Our Ref: 21453458.667

20 July 2023

Application reference: EPR-BP3537PP-V011
Operator: Biffa Waste Services Limited
Facility: Eye Landfill variation and consolidation with Willow Farm Landfill
Subject: Response to Non-Duly Made Letter dated 3 July 2023

Figure 1: Location of Discharge Point within P J Thory Permit to be transferred to Biffa (taken from Permit)

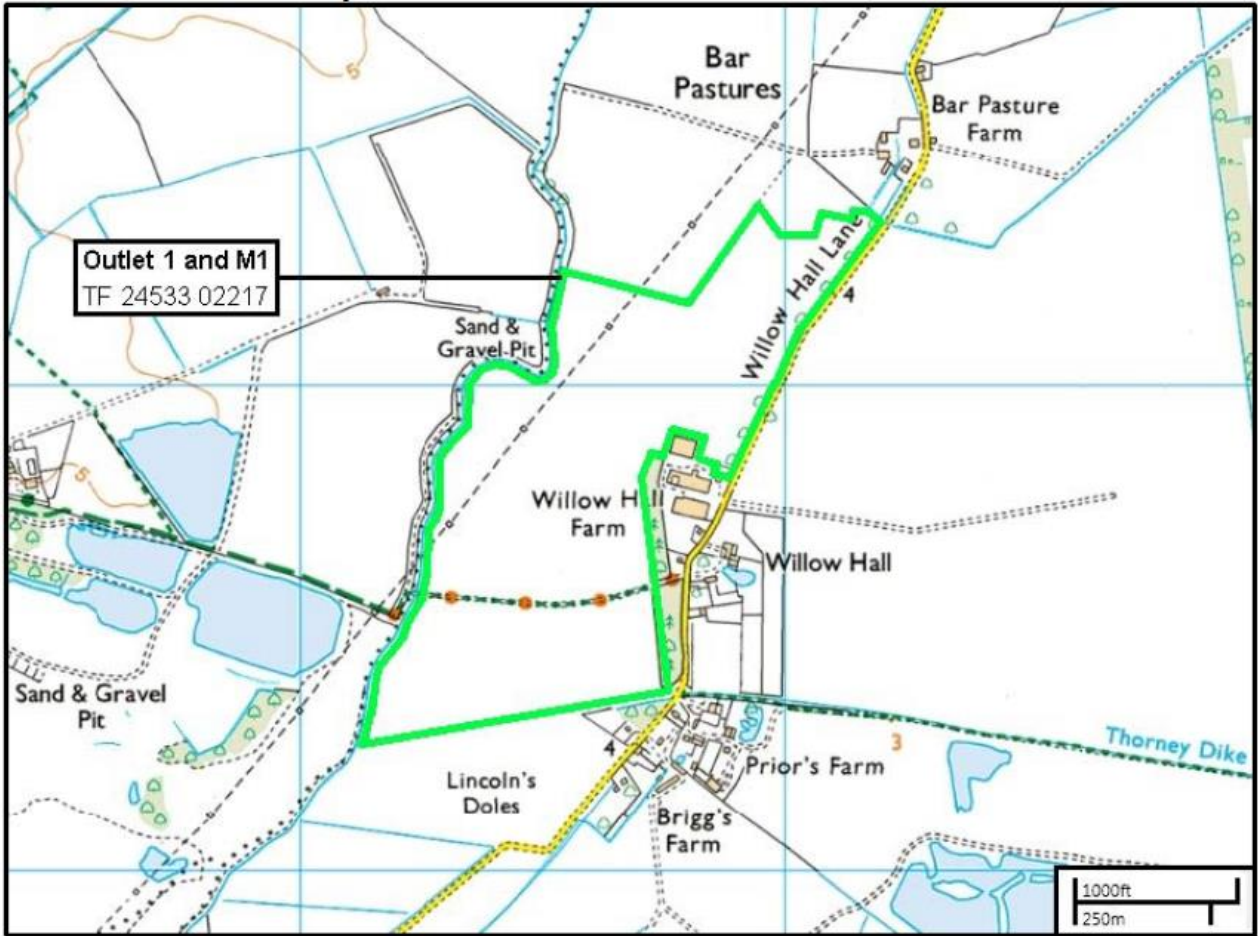
11. Please can you confirm which surface water monitoring and emission points have been renamed from the existing permit (EPR/BP3537PP/V010) and if there are any new or increased discharges.

In relation to the discharge point SW15, it is intended that existing Environmental Permit EPR/EB3091VZ that P J Thory holds for the discharge of trade effluent composed of quarry void and excavation dewatering to Cats Water Drain via Outlet 1 (as shown on **Figure 1**), will be transferred to Biffa with the intention of then incorporating the discharge consent and limits into the varied permit. The limits proposed for SW15 in the SWMP are based upon those already in place within the P J Thory Permit. The P J Thory Permit would then be surrendered. This discharge will continue to be used during development of the Site as a landfill, and once restored as part of the surface water management system within the proposed Wildlife Corridor. SW15 will therefore become a surface water discharge and monitoring point.

Figure 1: Habitat Sites within a 10 km radius of Eye Landfill

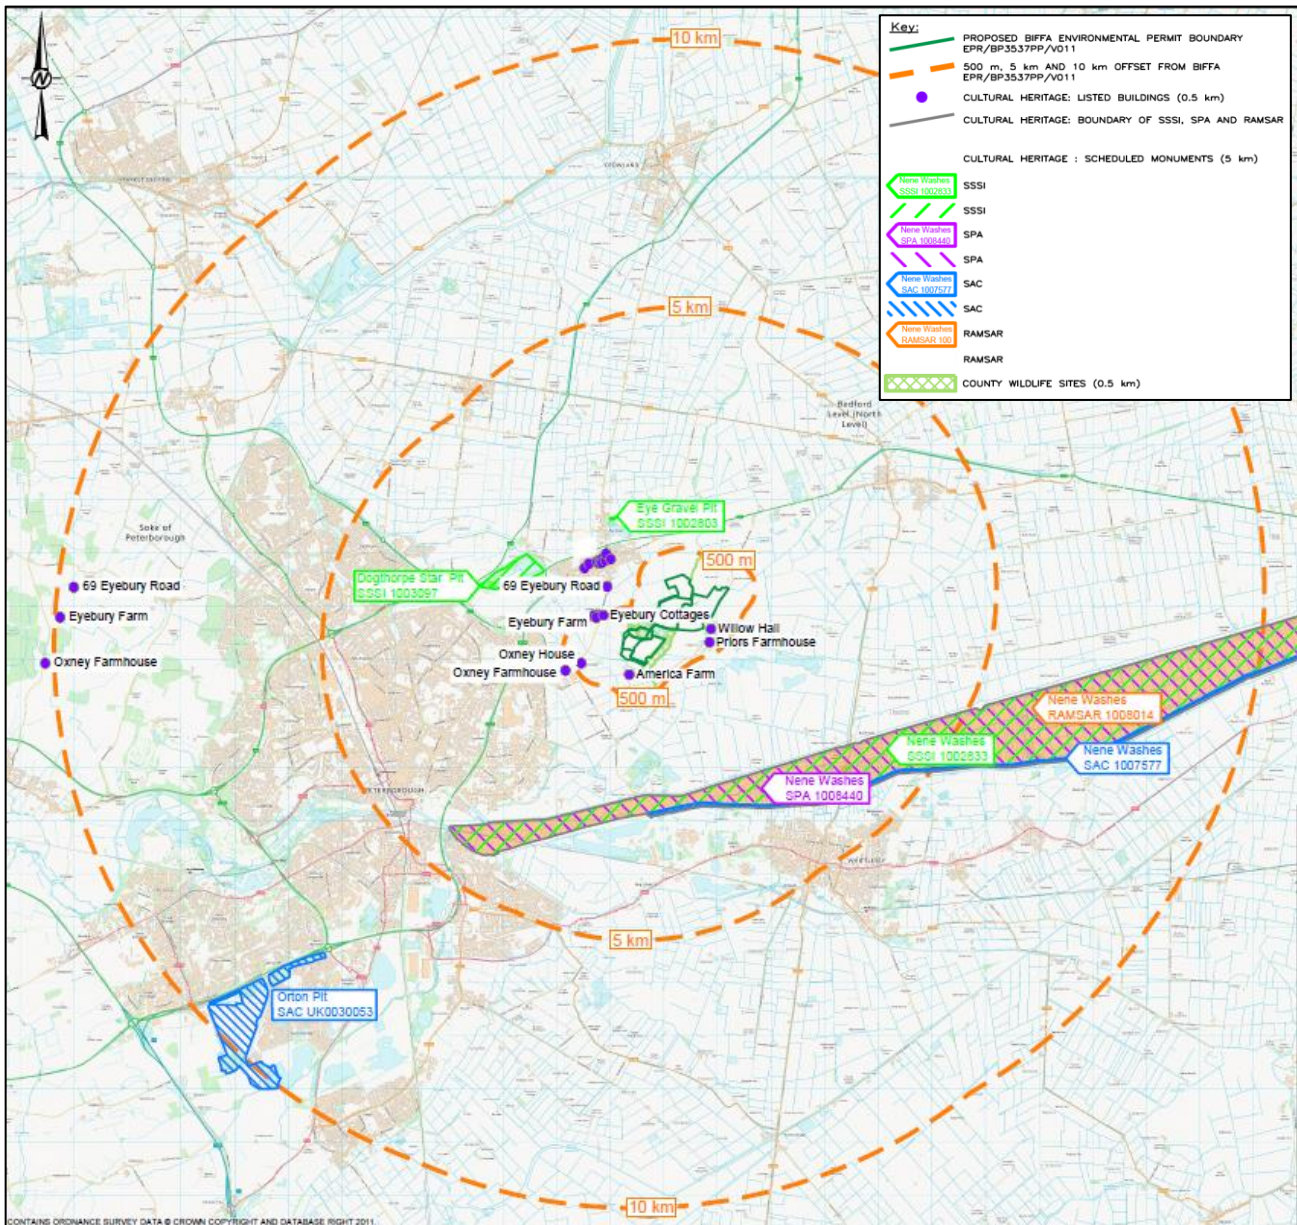
2. Orton Pit SAC is within 10km of the site - but this has not been included in the Habitats risk assessment – please update the habitats risk assessment.

We have updated Habitats Risk Assessment to include assessment of Orton Pit SAC. Please refer to **Annex 2**, report ref. 21453458.644 Version A.1.

The Nene Washes (SPA/SAC/Ramsar/SSSI) and Orton Pit (SAC/SSSI) were identified as being within 10 km of the Site boundary; it is these Sites which are the subject of the remainder of this report.
